Transmission Expansion Advisory Committee: AEP Supplemental Projects

Changes to Existing Needs

AEP Transmission Zone M-3 Process Van Wert Area Customer

Need Number: AEP-2025-OH019

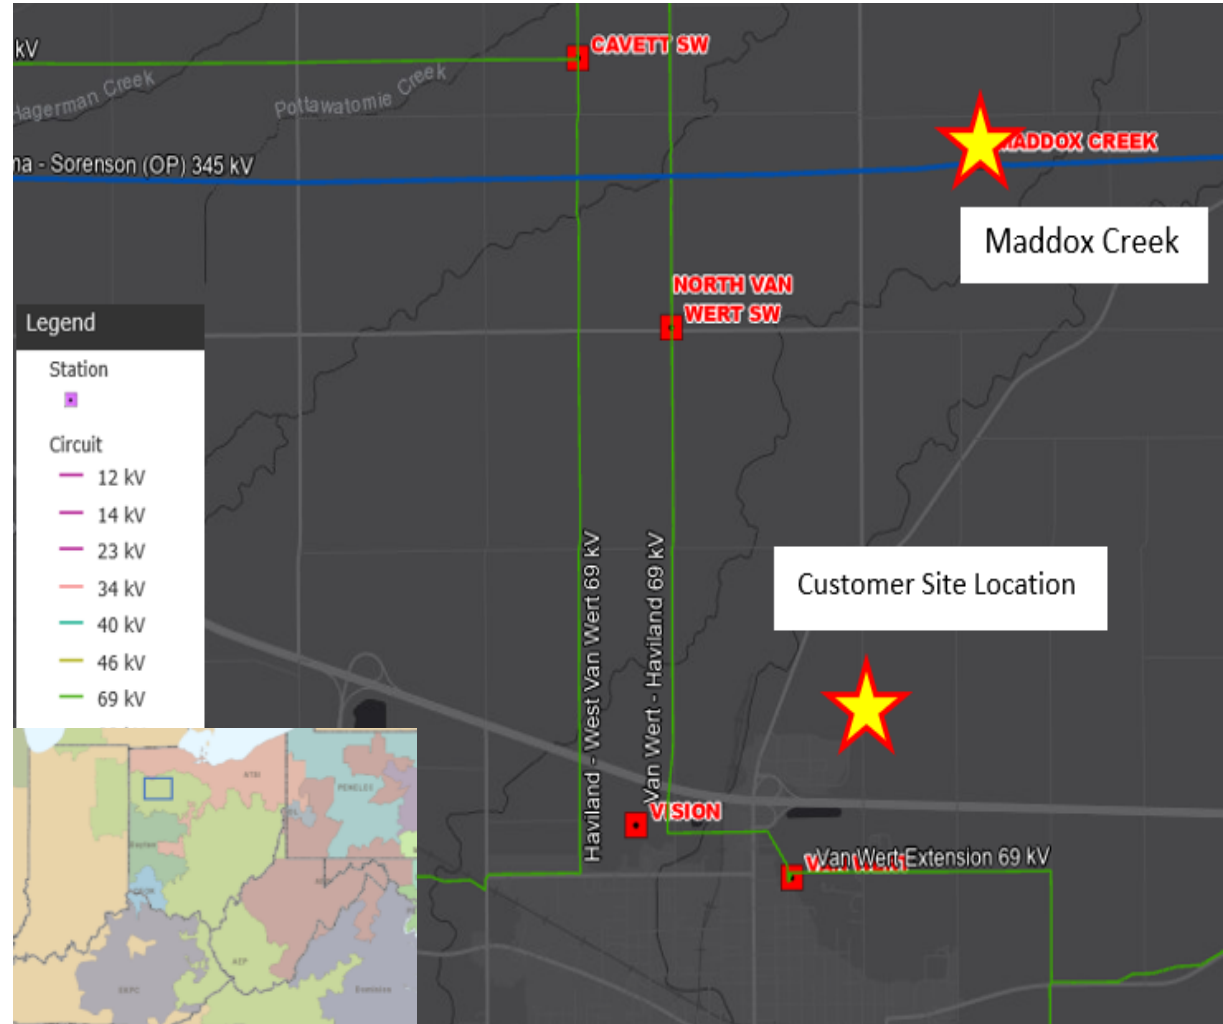
A Customer has requested 345 kV transmission service for **1,300 MW** at a site south of AEP's existing Maddox Creek station in Van Wert, OH. The customer's initial load is 500 MW and expected to be in service by 12/31/2028. **The remaining 800 MW is expected to be in service by Q3 2031.**
